**STATE OF CONNECTICUT
CONNECTICUT SITING COUNCIL**

DOCKET NO. 366

APPLICANTS' REBUTTAL REPORT AND TESTIMONY REGARDING WETLANDS

Re: Docket Number 366
Rebuttal of Comments in Danzer Letters/Reports dated November 19, 2008
and December 22, 2008

SHEET NUMBER:
C02

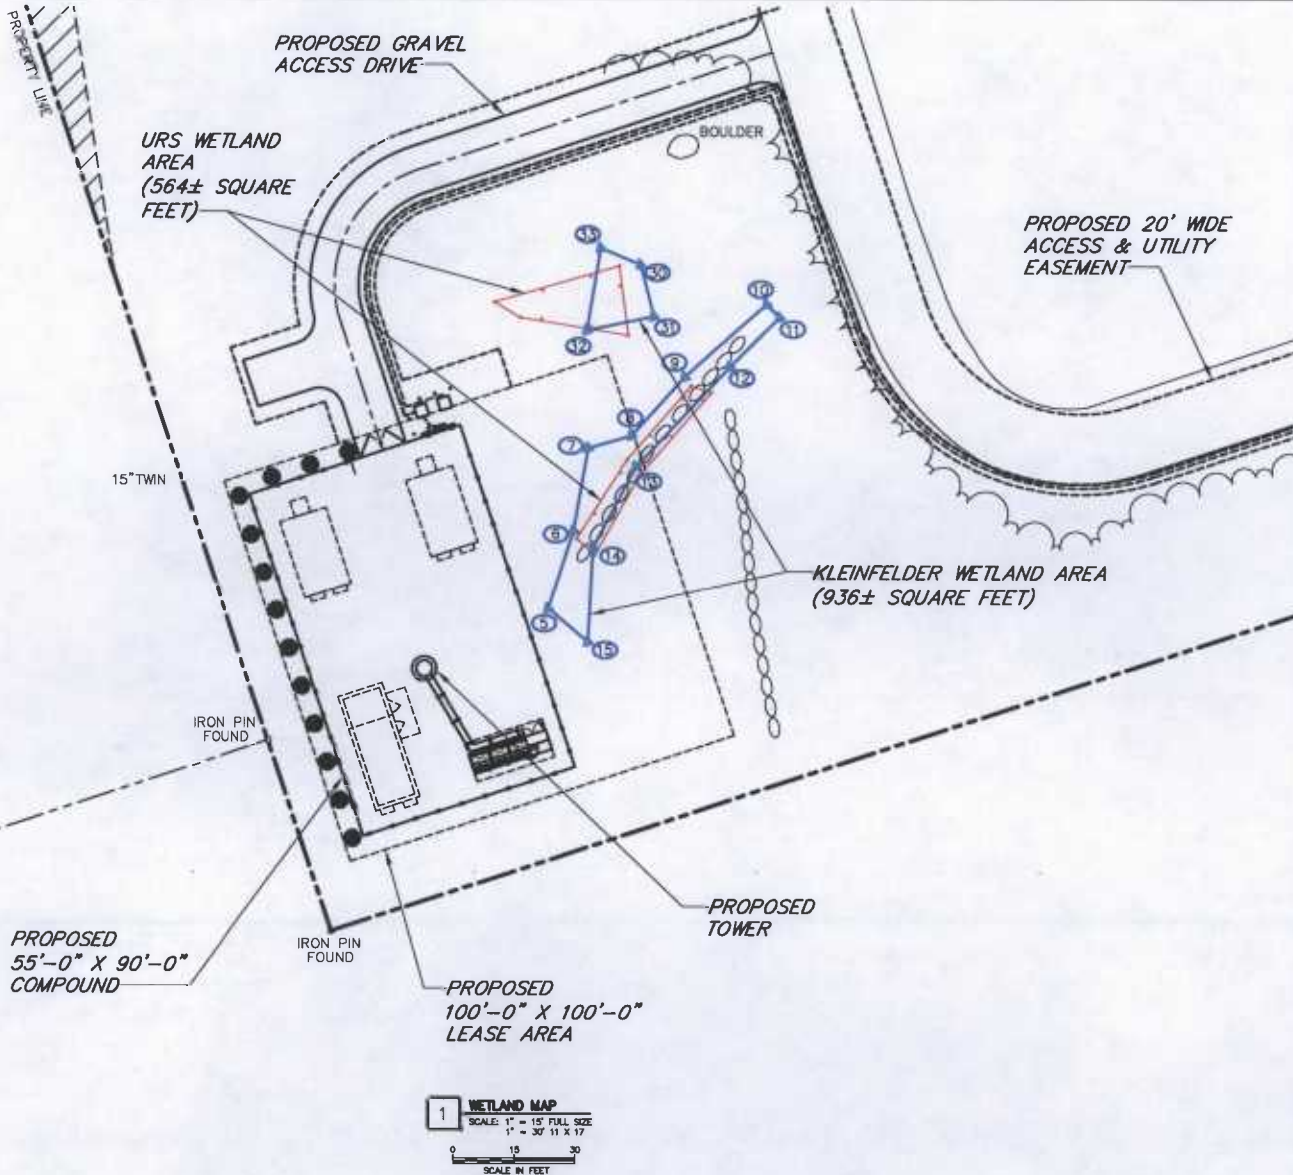
Danzer Comment: Differences in delineated wetland sizes and shapes, and suggestion that they are not isolated but rather part of a larger historical wetland.

Response: The attached figure from CHA (sheet CO2) depicts both the URS delineated wetland areas and the Kleinfelder delineated wetland areas. The total wetland area delineated by URS was 564 square feet. The total wetland area delineated by Kleinfelder was 936 square feet. Two differences between the delineations are apparent. First the northern depressional wetland is smaller and of a slightly different shape in the Kleinfelder delineation. Based on the URS delineation the northern wetland is approximately 35 feet east of the access road at its closest point, and 45 feet from the access road based on the Kleinfelder delineation. Both are significant distances and based on both delineations there will be no direct impact to this wetland. The closest distance from the compound to the northern wetland is the same for both delineations. The Kleinfelder delineation of the southern, linear wetland along the stone wall, identified more area to both the northeast and southwest of the stone wall. This delineation results in a larger wetland area which is closer to the proposed compound and is therefore the more conservative of the two delineations.
